HumeLink

Amendment Report

Rev 0

May 2024

Source: Aurecon, Transgrid, Spatial Services (DCS), ESRI Basemap

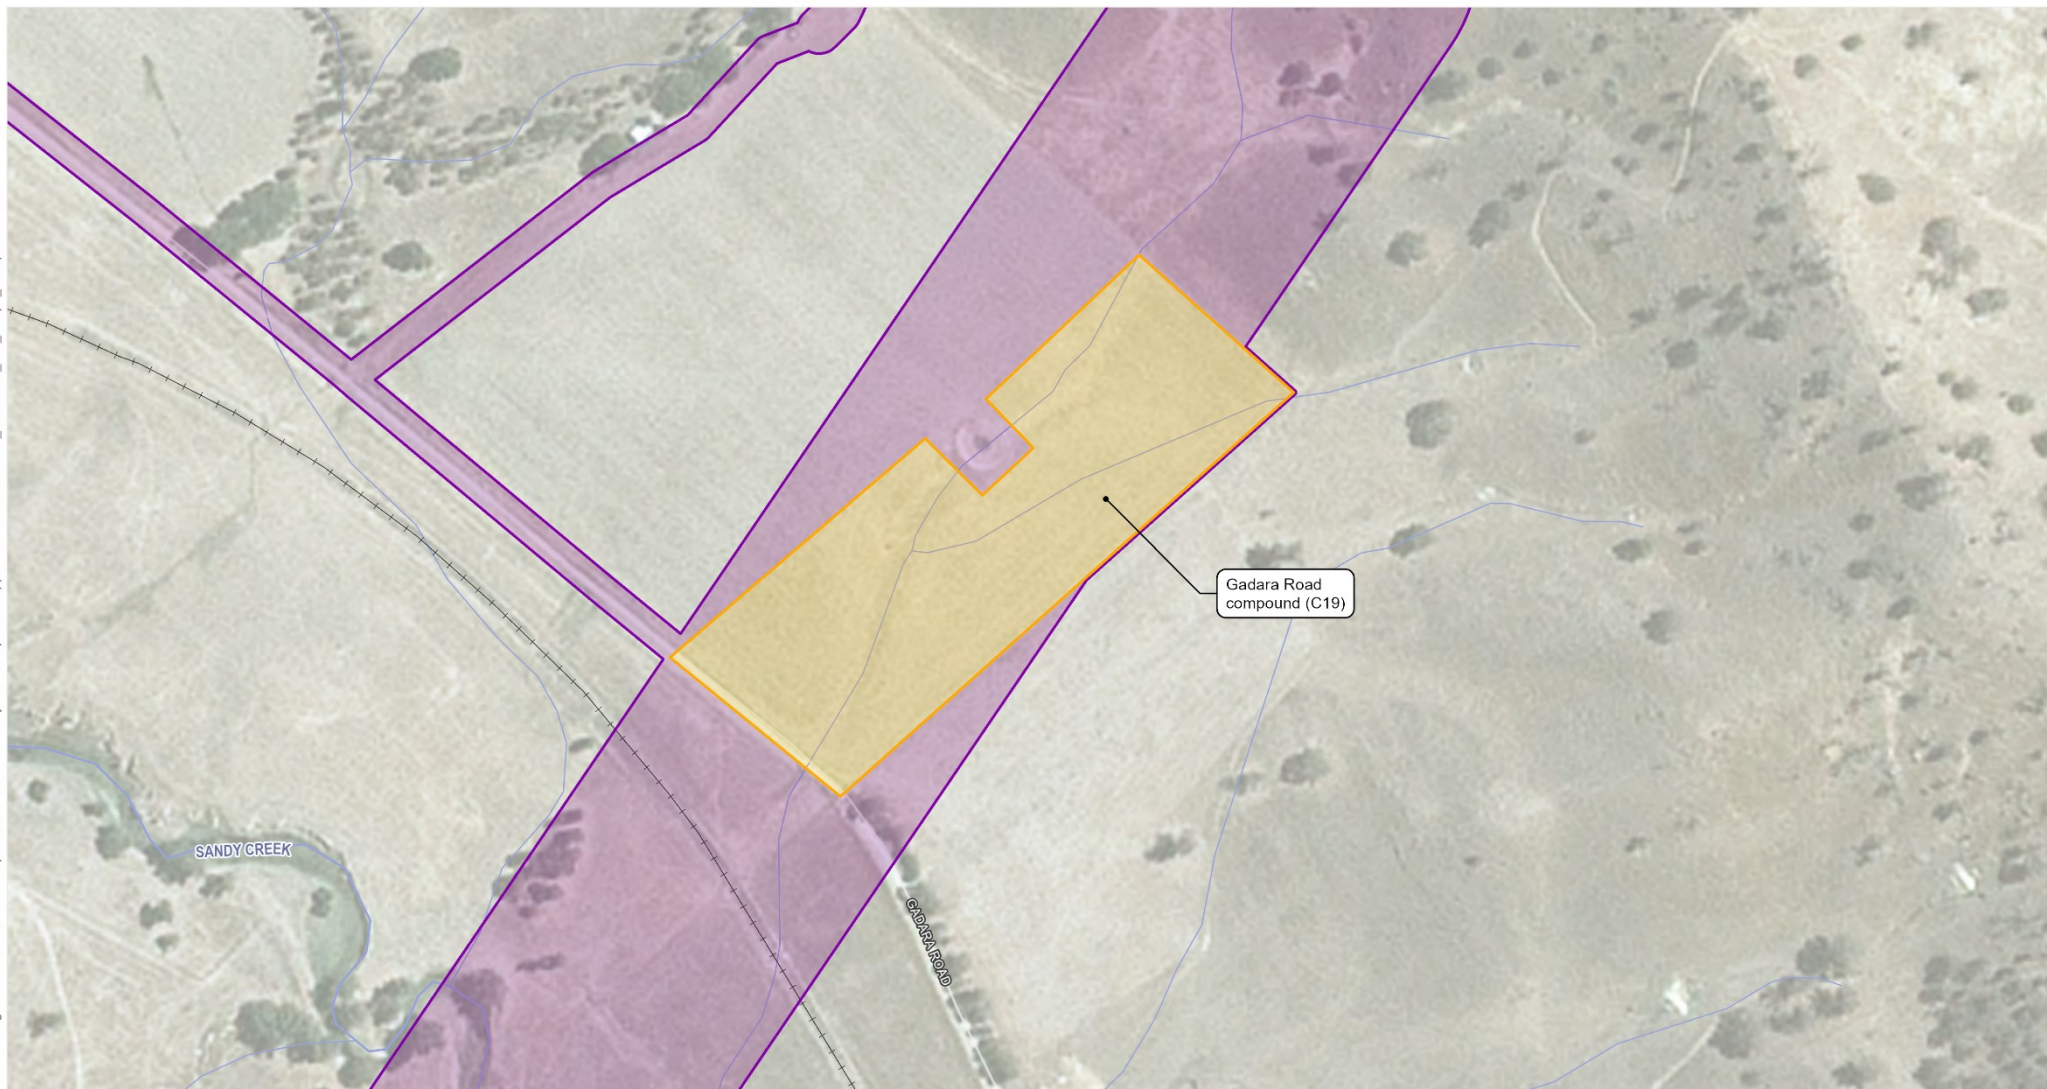
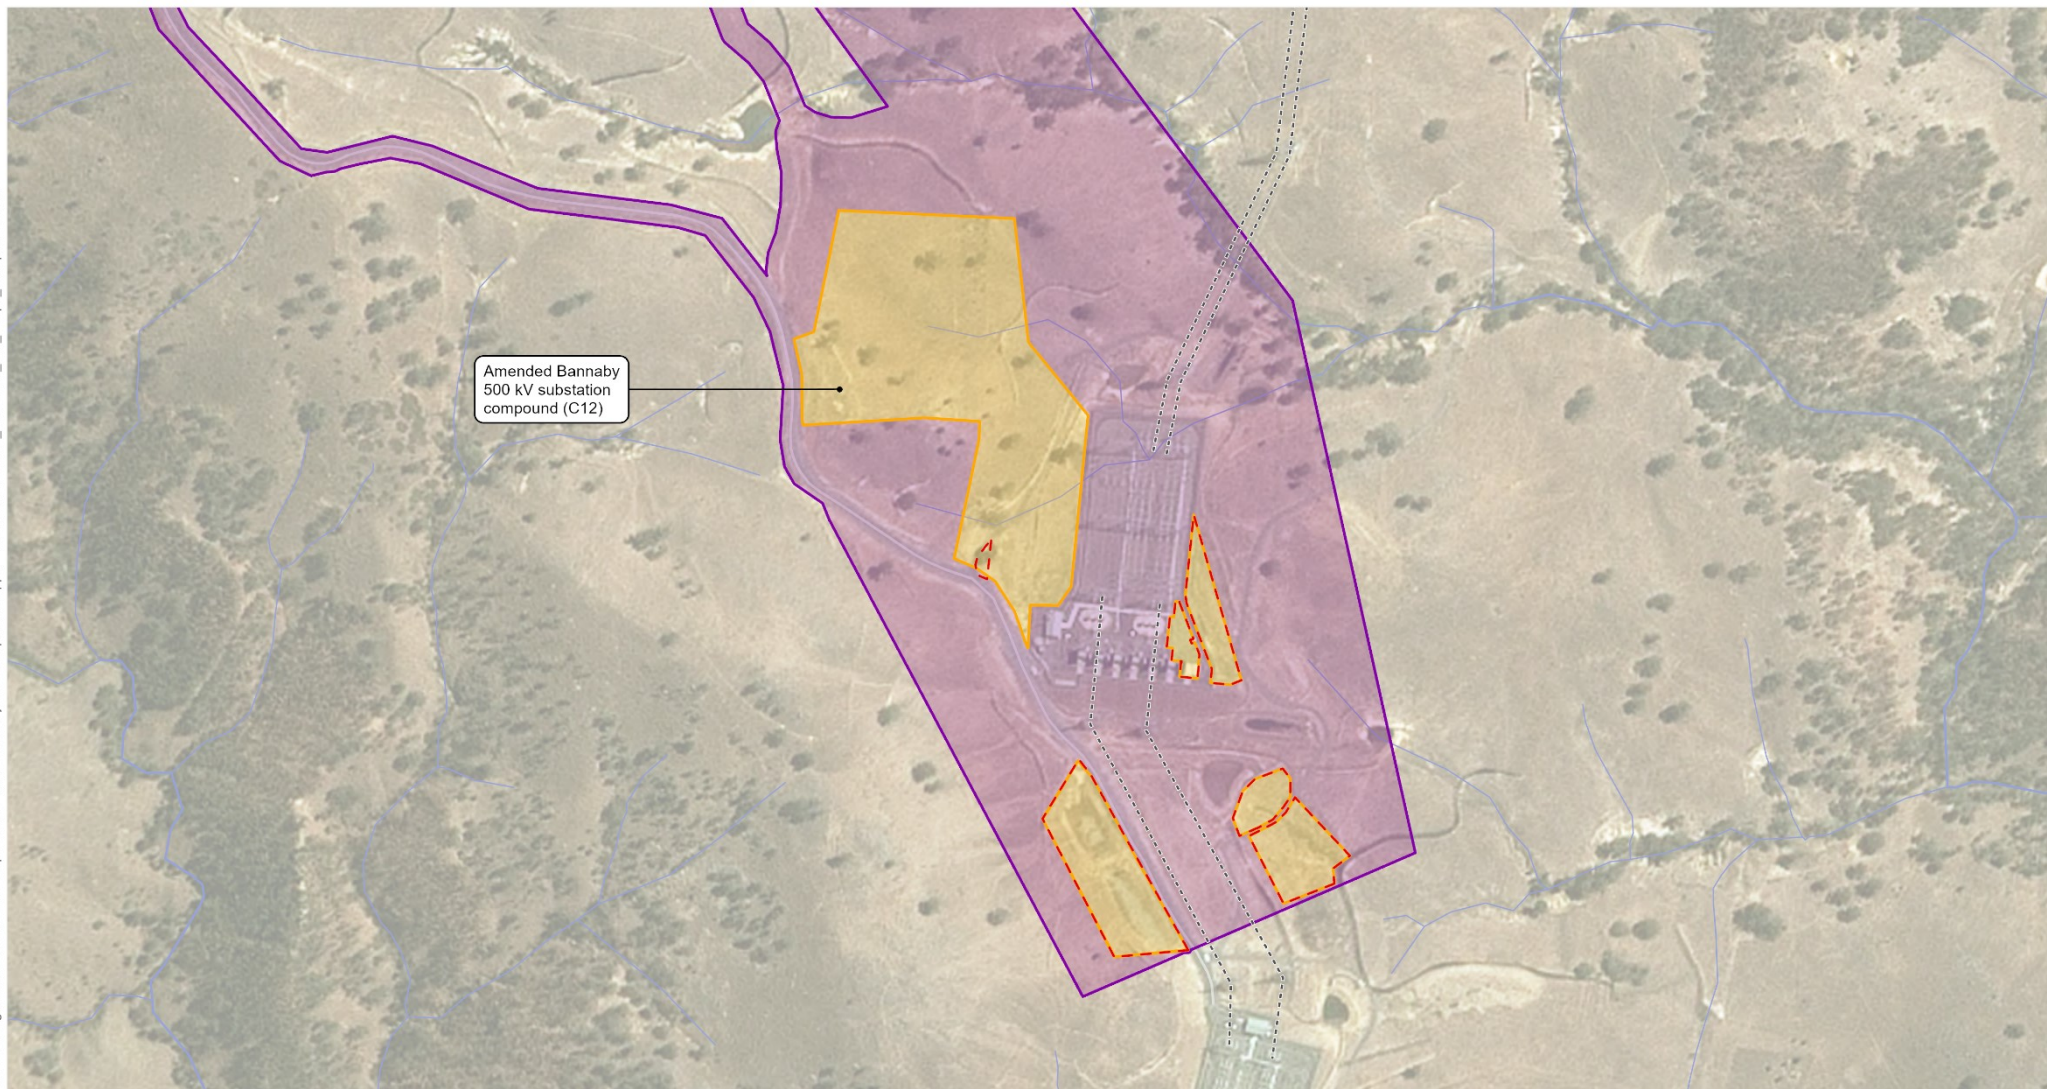
Table 3-4 provides a consolidated list and description of the standalone construction compounds. Further detail is provided in Appendix A (Updated project description). Figure 3-4 shows the locations of the changed standalone construction compounds.
